TECHNICAL NOTE

Santa Sophia College

Response to SSDA Submissions

Figure 1: Temporary Carpark

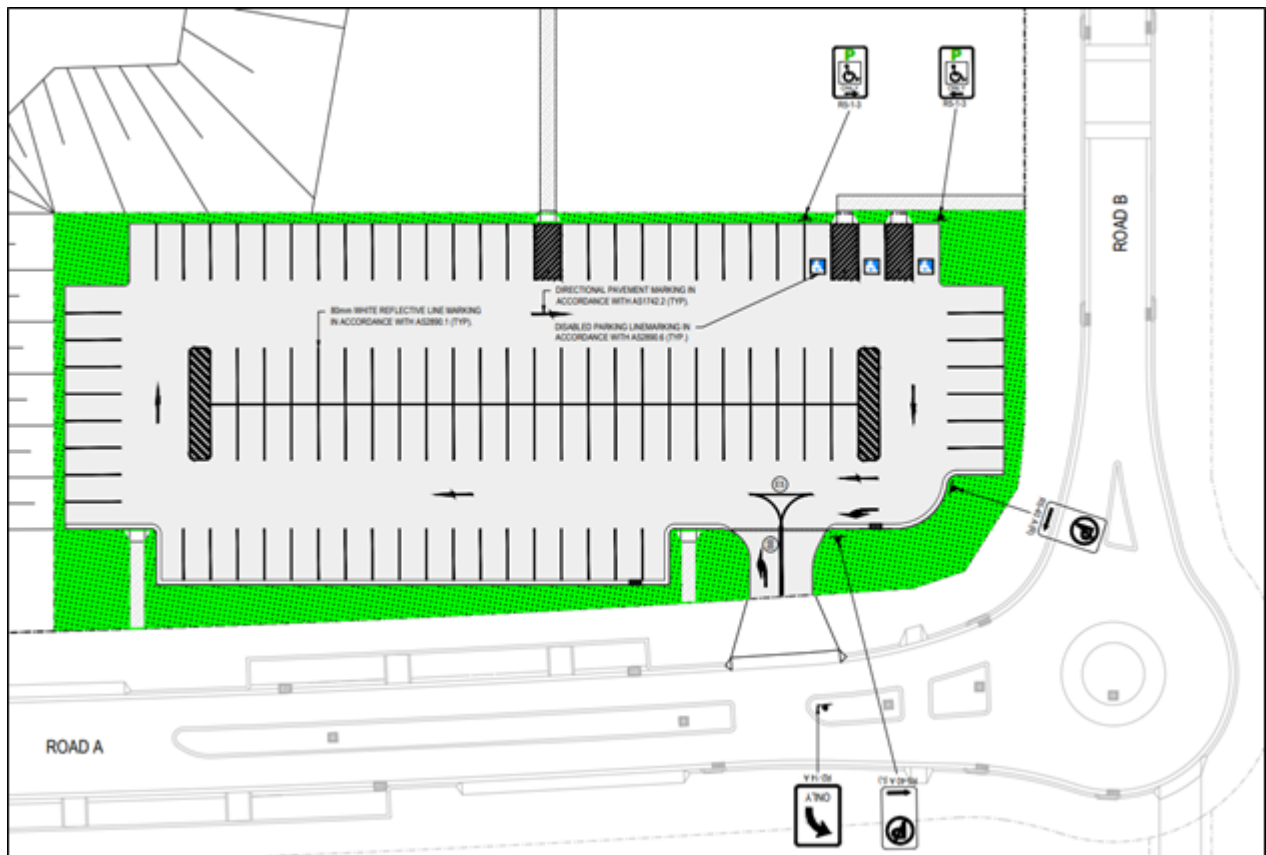
Limited detail is provided in relation to the parking relied upon off site. It is noted that the description of the proposal identifies “Off-site staff car parking”. Clarification is sought as to whether this forms part of this application or, as anticipated, whether it is intended to be lodged as a future application. In any event the limitations on the use outside of standard school hours are questioned given the limited opportunities for on-site parking or availability of public transport.

In the short term, this staff parking will be provided within a temporary car park immediately adjacent to the Site (see **Figure 1**) until such time that the permanent parking area is provided. A formal staff car park will be provided within the immediate vicinity of the College, and that the temporary staff car park would remain in place until such time as the new car park is fully operational. The provision of this permanent car park will be subject to future agreement between the CEDP and Celestino; this new car park would be strictly reserved for College staff during school periods, outside of which it could be utilised by the general public.

Figure 7: Proposed Pick-Up / Drop-Off Facilities

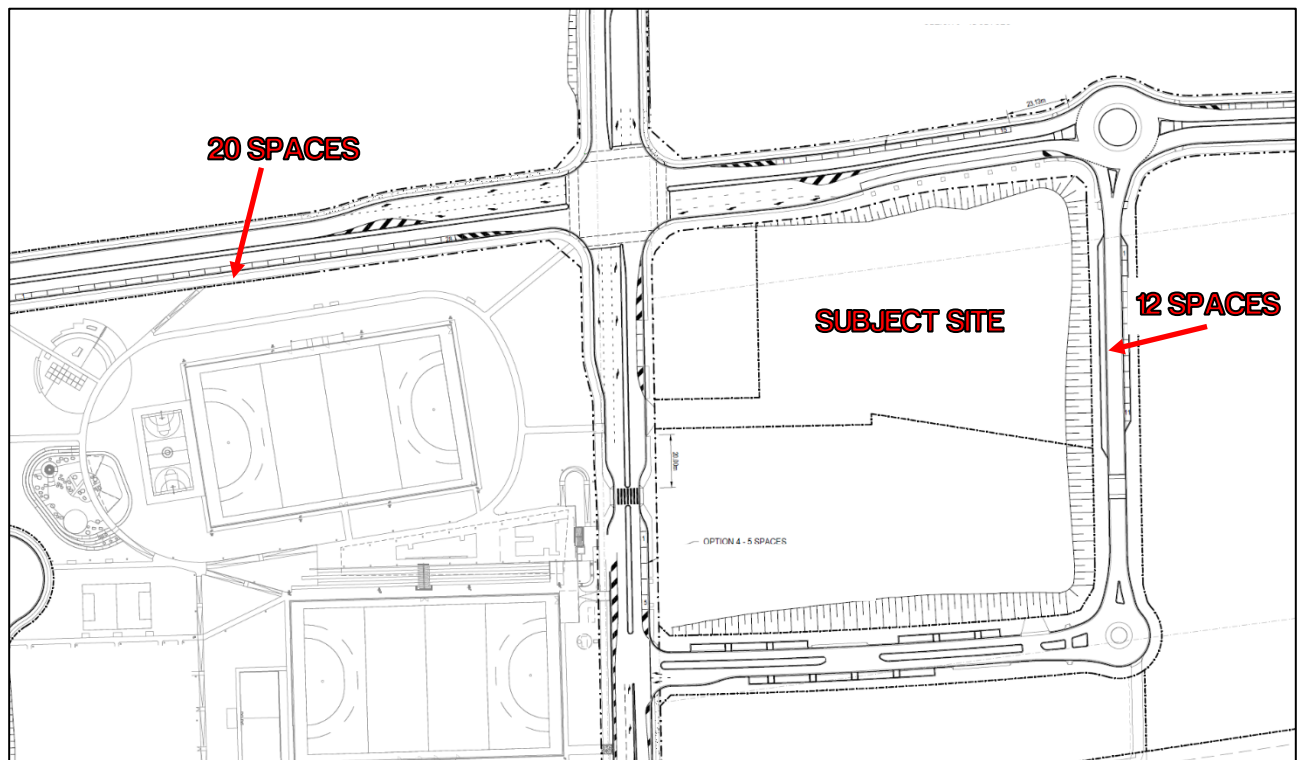
- To detail the pick-up / drop-off area demand in accordance with TfNSW comments, and
- Assess the capacity of the separate pick-up / drop-off areas for the primary and secondary school.

Due to the location of the second pick-up / drop-off area on Fontana Drive, this area would be for secondary school students, while the Road B pick-up / drop-off area is dedicated for the primary school only.
